CPED STAFF REPORT
Prepared for the City Planning Commission

CPC Agenda Item #5
June 23, 2014
BZZ-6417

Property Location: 312 Lake Street West
Project Name: Karmel West
Prepared By: [Brad Ellis](#), Senior City Planner, (612) 673-3239
Applicant: Karmel West, LLC
Project Contact: Basim Sabri
Request: To construct a second story addition above an existing commercial building.
Required Applications:

Preliminary Development Review Report

A3 PROPOSED WEST ELEVATION W/ NEW SECOND FLOOR CANOPY
 3/32" = 1'-0"

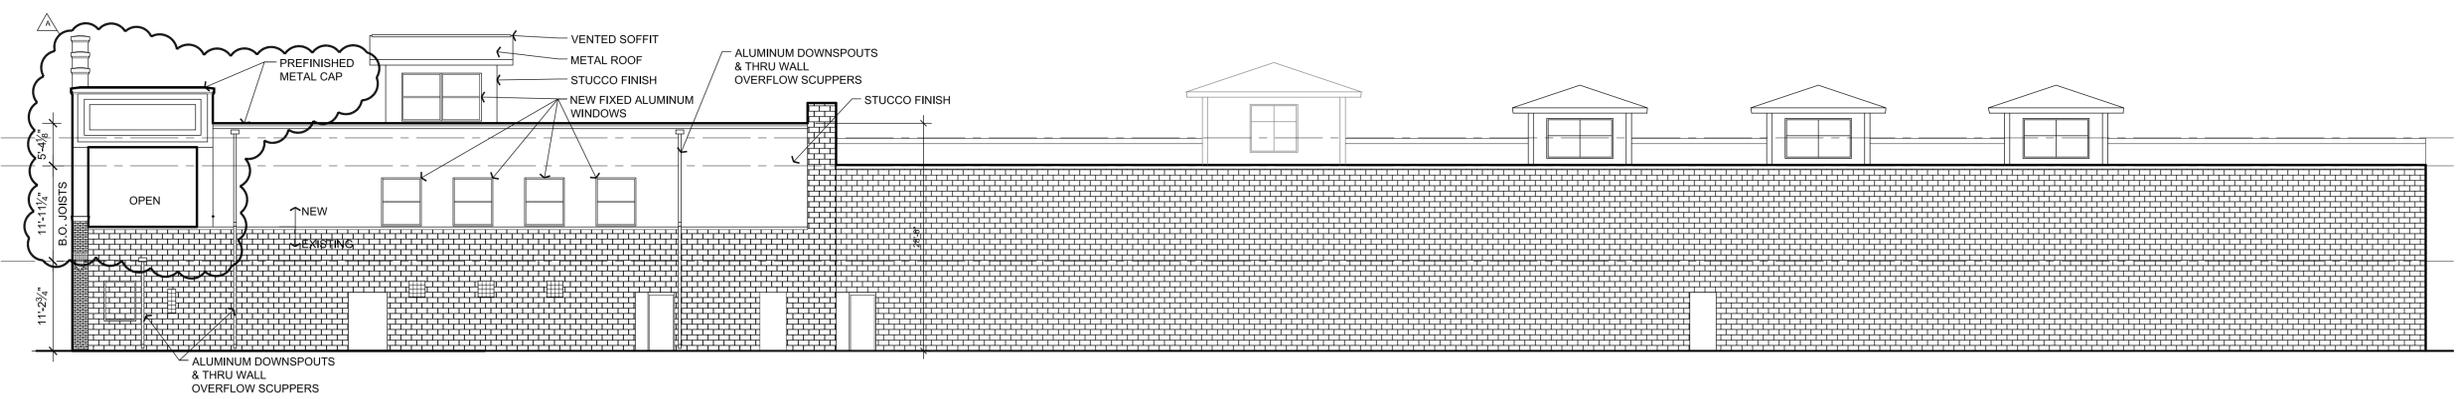
During the review process, staff noticed that the submitted drawings do not match what was constructed on the site. In addition, there appears to be mechanical equipment extending over the property line on the west side that is not reflected in any submitted plans. Final plans shall be required to reflect actual construction that meets any approvals of this site plan review.

- **Blank, uninterrupted walls shall not exceed 25 feet in length.** Alternative compliance is requested for the maximum 25 foot length of blank, uninterrupted walls along the west elevation of the addition. The western elevation is along the property line of 318 Lake Street West, and the building code does not allow openings within three feet of a shared property line. There is also the potential for redevelopment of the 318 Lake Street West site, which would obscure any architectural details on the addition at 312 Lake Street West. Staff recommends alternative compliance be granted.

7. The parapet shall be flat and shall extend no higher than forty-two 42 inches above the roof.
8. The applicant shall provide proof of easement for the mechanical equipment on the west façade of the addition or shall be required to move it to the interior.

A1 PROPOSED SOUTH (LAKE STREET) ELEVATION W/ NEW 2ND FLOOR CANOPY
 3/32" = 1'-0"

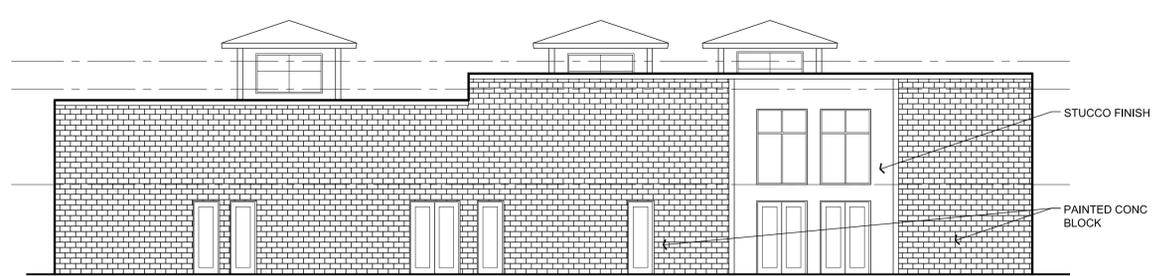
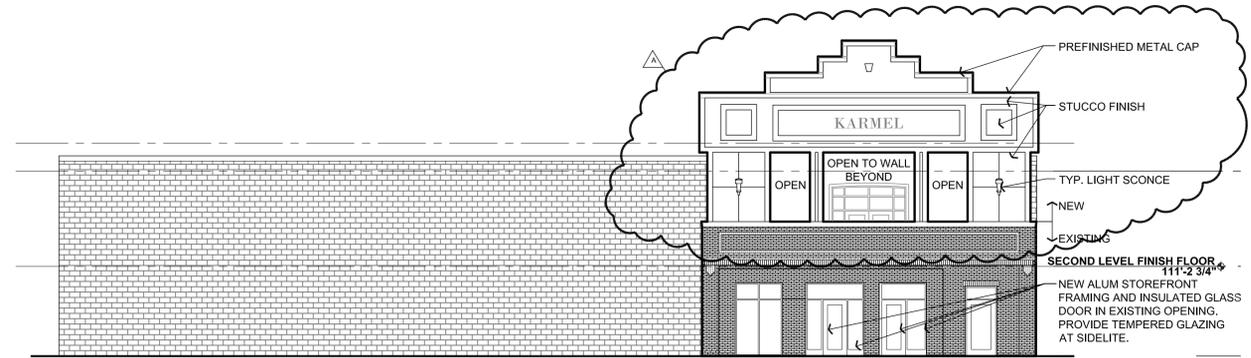
- The structure has a flat roof similar to other structures in the area; however the building façade has an unusually large parapet that is not in keeping with the form and pitch of surrounding buildings. Staff is recommending a condition of approval requiring the removal of the extended parapet.

- **Form and pitch of roof lines shall be similar to surrounding buildings.** Alternative compliance is requested for the 11 foot tall pyramid parapet above the addition. The parapet is not in keeping with the form and pitch of roof lines in surrounding buildings. Staff is recommending alternative compliance not be granted, and that a condition of approval be placed requiring the removal of a substantial portion of the parapet in order to comply with this requirement.
